Request for Class II Permissive Change(C2PC)

FCC ID: VG8XM044KYY-GE

Data: 2019-10-15

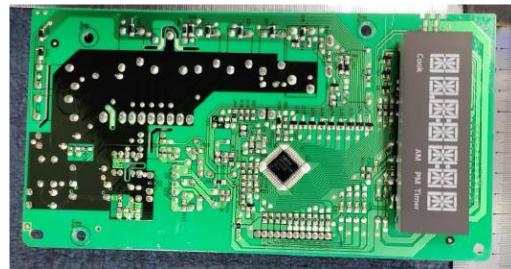
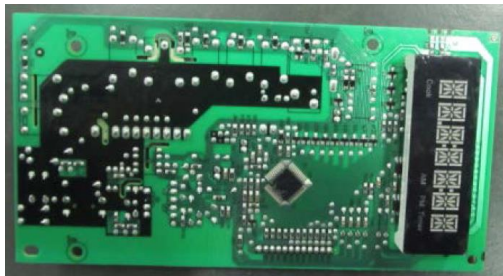
1. This Application is based original FCC ID:VG8XM044KYY-GE which granted on12/28/2015.
2. Changed high-voltage capacitor's parameter making input power from 1550W to 1500W, output power from 1000W to 900W.
3. Added new model as "CVM1655*****, JVM163*****(* express 0~9, A~Z, or blank)". New models are identical to model tested EM944KXA-GE except model name. they are only named differently for marketing purpose.
4. Changed high-voltage transformer'model as "MD-903AMR-1".
5. Product's Exterior is identical to original.(see below photos):

Original

new

Original

new

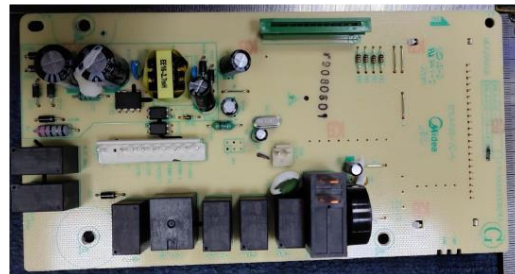
Back view is basically identical to original.
